MONTGOMERY COUNTY HISTORIC PRESERVATION COMMISSION
STAFF REPORT

| Address: | 7301 Willow Ave., Takoma Park | Meeting Date: | 9/4/2024 |
| Case Number: | 1078975 | Staff: | Dan Bruechert |
| Proposal: | Solar Panel Installation | | |

Figure 2: Proposed solar layout (Willow Ave. is on the left side of the diagram).

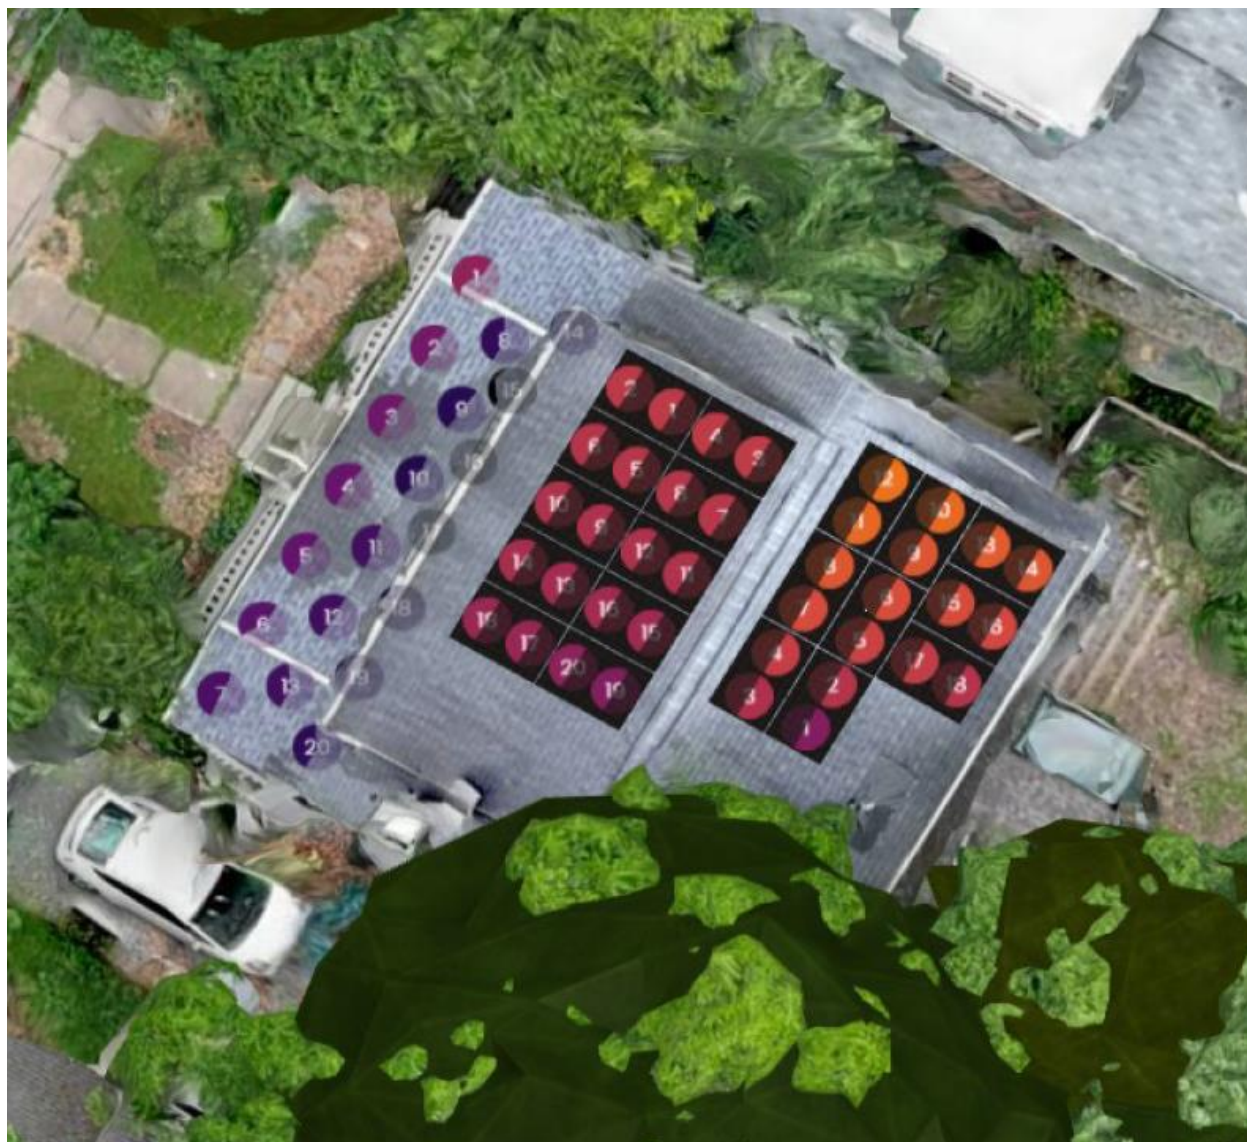
The subject property is a one-and-a-half-story Craftsman with a large shed dormer on the front. The roof is covered in architectural shingles. The applicant proposes to install 19 (nineteen) solar panels on the house roof. The proposed solar panels are arranged in two arrays, with ten panels installed in a 2×5 (two panels tall by five panels wide) pattern on the front dormer roof, and the remaining nine panels installed on the rear roof slope.

The 9 (nine) solar panels proposed on the rear roof slope will not be at all visible from the public right-of-

way, in a location that is identified as a ‘preferred location’ for solar panels under the HPC’s adopted solar panel policy, HPC Policy 20-01.

The applicant proposes to install the remaining 10 (ten) solar panels on the front-facing dormer in a 2×5 (two panel tall by five panel wide) configuration. The proposed array is shifted to the north (left) of the roof’s center to avoid the shade created by the large trees to the south.

Staff recommends the HPC approve the nine rear solar panels under 24A-8(b)(2) and (d), the *Design Guidelines*, and Standards 2, 9, and 10.

Monthly Consumption and Production (kWh)

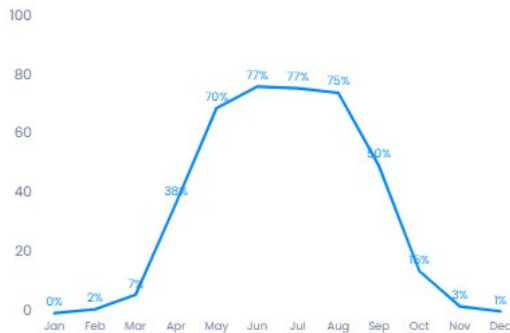
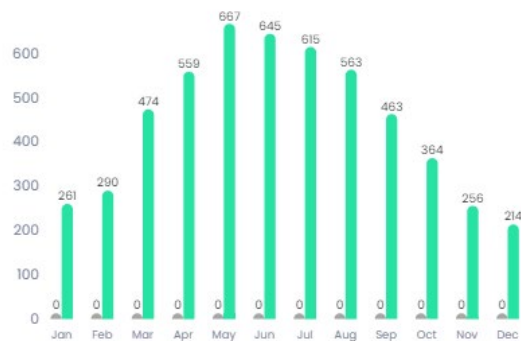
- The home had an annual usage of roughly 5,210 kWh in 2023. Our proposed system is estimated to have 5,369 kWh in annual production.

- All usable space on the rear-facing roof plane is being utilized in this design without placing panels beneath the overhanging tree. The panels on the rear plane produce more than the panels on the front, but without the front panels, the system would only produce around 2,798 kWh annually.
- There are no alternative roof planes to use besides the front-most plane, which would have low production and higher visibility from the road.
